HIGHWAY WORK PROPOSAL

Proposal Number: **028**

<u>STATE ID</u>	<u>FEDERAL ID</u>	<u>PROJECT DESCRIPTION</u>	<u>HIGHWAY</u>	<u>COUNTY</u>
1470-27-71	N/A	Manitowoc-Two Rivers, E Magnolia Ave-12th Street	STH 042	Manitowoc
1470-33-71	N/A	City of Two Rivers, Washington St, West Twin River Bridge B360117	STH 042	Manitowoc
1470-37-71	N/A	Manitowoc - Two Rivers, Waldo Blvd - E Magnolia Ave	STH 042	Manitowoc

ADDENDUM REQUIRED ATTACHED AT BACK

Addendum No. 01
ID 1470-27-71
ID 1470-33-71
ID 1470-37-71
Revised Sheet 13
February 4, 2025

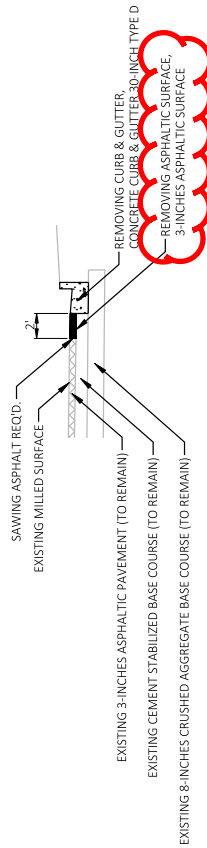
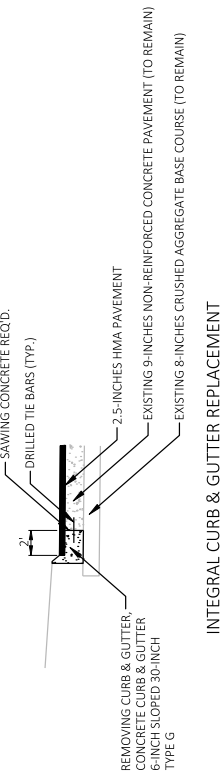
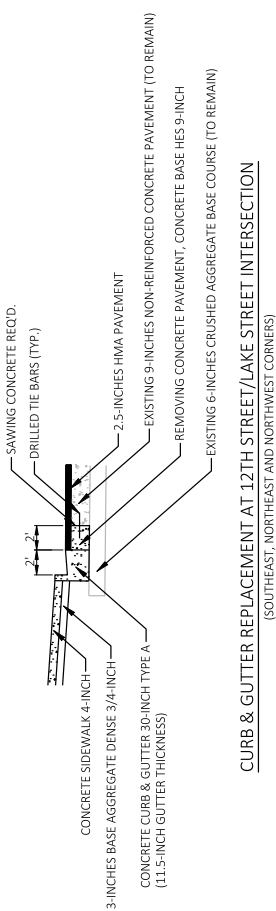
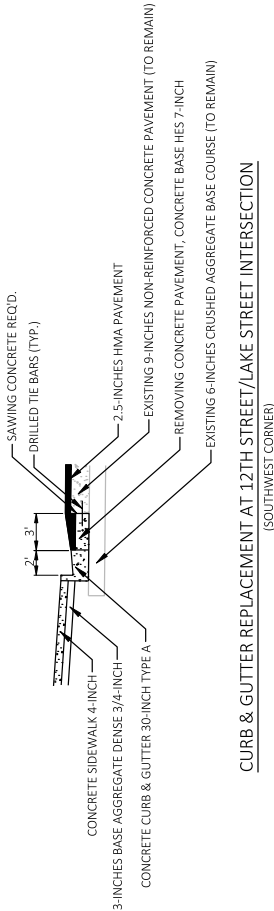
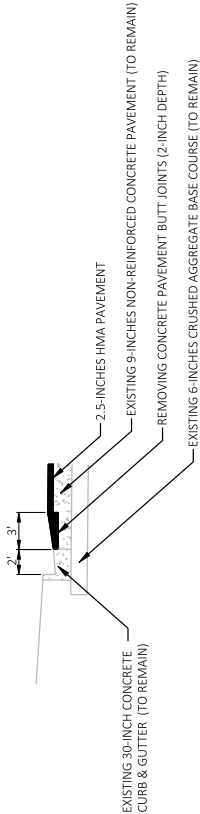
FINISHED TYPICAL SECTION - STH 42

STA. 130+51 - STA. 184+19, LT
STA. 184+19 - STA. 199+34, LT
STA. 200+41 - STA. 205+79, LT
STA. 209+54 - STA. 240+94, LT
STA. 242+84 - STA. 257+04, LT
STA. 258+04 - STA. 295+76, LT
STA. 302+04 - STA. 333+04, LT

Storm Sewer Replacement Trench Detail

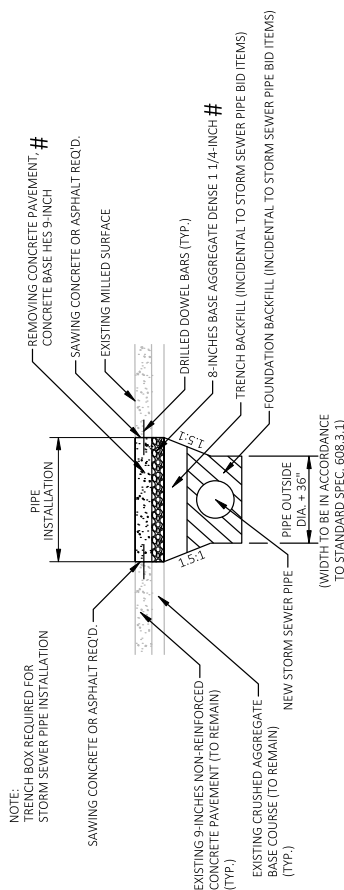
PIPE INSTALLATION AREA WILL FOLLOW SECTION 608 FOR INSTALLATION, WIDTHS AND PAYMENT.
CONSTRUCT TRANSITION PERPENDICULAR TO STORM SEWER PIPE.
PAVEMENT SAW CUT TO BE PERPENDICULAR TO ROADWAY ALIGNMENT.
HMA SHOULDER PAVEMENT STRUCTURE SHALL BE: 3-INCHES ASPHALTIC SURFACE OVER 14-INCHES BASE AGGREGATE DENSE 1 1/4-INCH #. HMA SHOULDER PAVEMENT SHALL BE PAID FOR AS EXCAVATION COMMON.

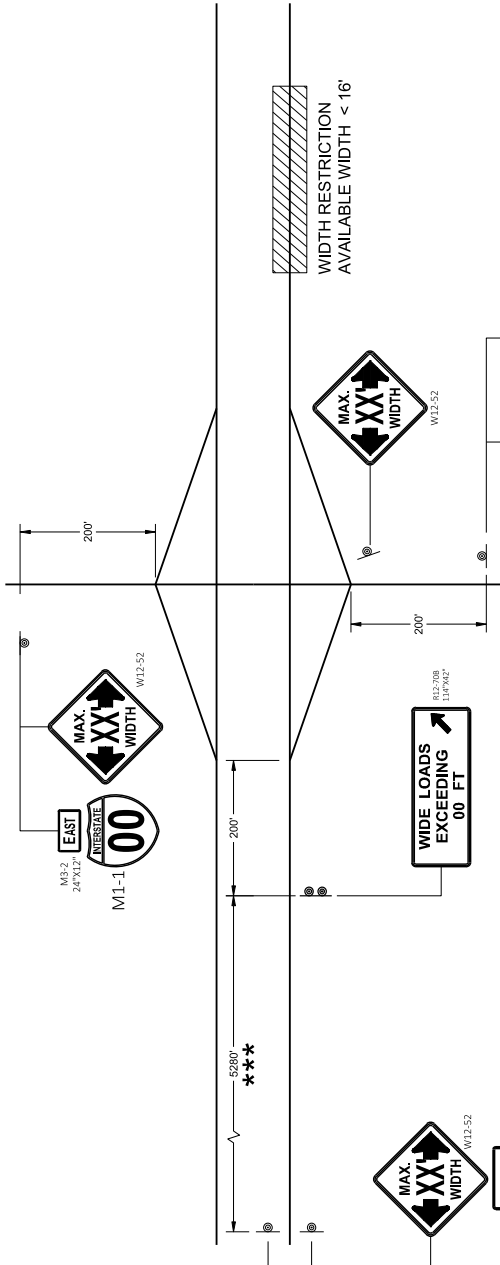
WIDTH ON SIGN TO BE APPROXIMATELY ONE FOOT LESS THAN AVAILABLE WIDTH.

PLACE 500 FEET AFTER THE W20 - 1A AND 500 FEET BEFORE ADDITIONAL SIGNS FOR ROADWAYS WITH A PRE - CONSTRUCTION SPEED LIMIT OF 45 MPH OR MORE. FOR 35-40 MPH, USE 350 FOOT TYPICAL SPACING. FOR 25-30 MPH, USE 200 FOOT TYPICAL SPACING.
